ENGINEERING BULLETIN No. 20

**Inspection Front Stabilizer Fittings
Part No. 18128**

Bulletin 20 refers to Models 8, 8A, 8B, 8C, 8D. P. S. If you have sold your airplane please forward this to the new owner.

CUT AWAY
AFT PORTION FUSELAGE
SHOWING LOCATION OF
FITTING 18128 L & R
(TAIL SURFACES REMOVED)

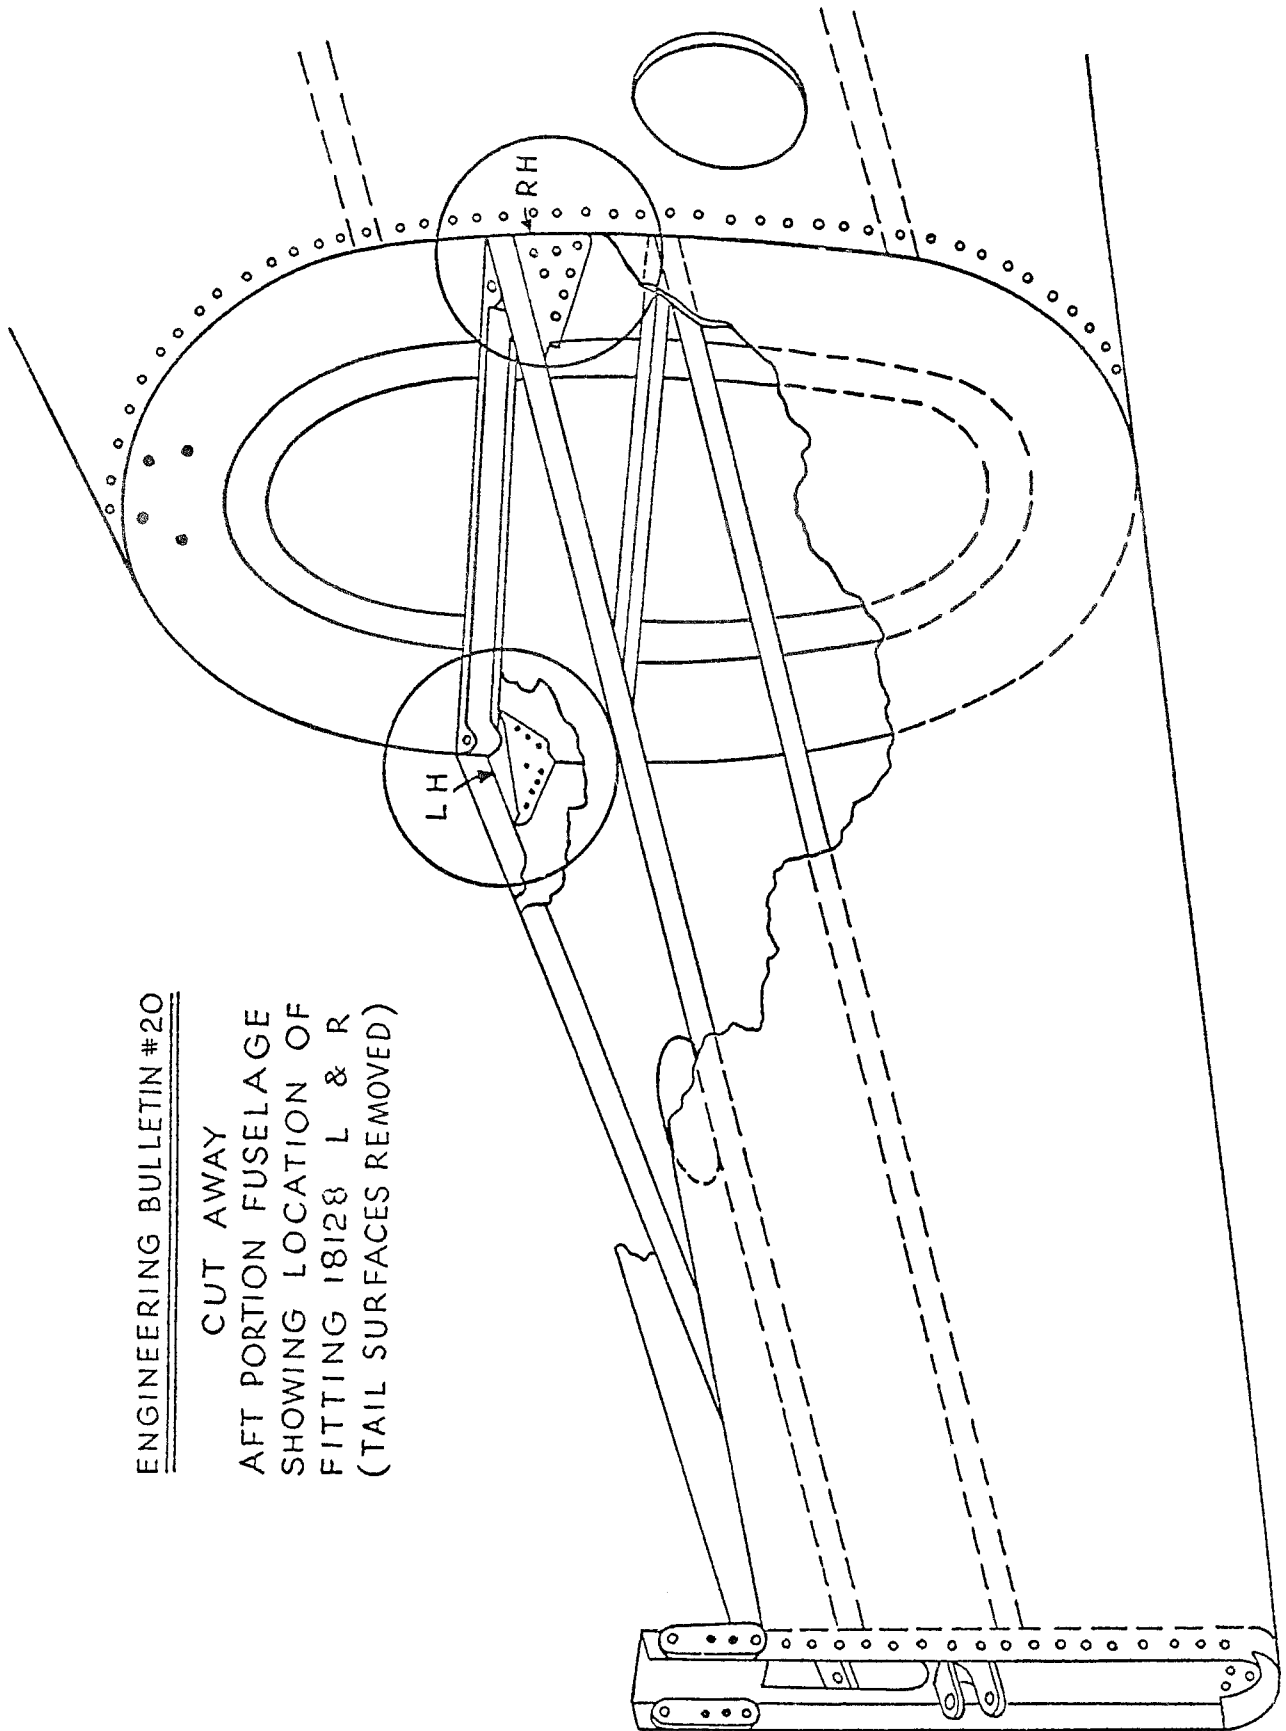
The attachment fitting for the stabilizer Part No. 18128 should be immediately inspected as follows:

Remove the fairing between the fin and stabilizer on both sides. Remove the inspection plate under the righthand stabilizer in the fuselage splice strip. The part in question then can be inspected with a dental mirror and flashlight. The bolts which hold the stabilizer to this part should be removed so that cupping effect or cracking adjacent to the head of

the bolt will be evident. Only one failure of this type has been reported.

If this fitting is cracked, it should be replaced by a new type fitting which will be available for this purpose. The price of the new fitting will be determined later and necessary figures will be available upon request.
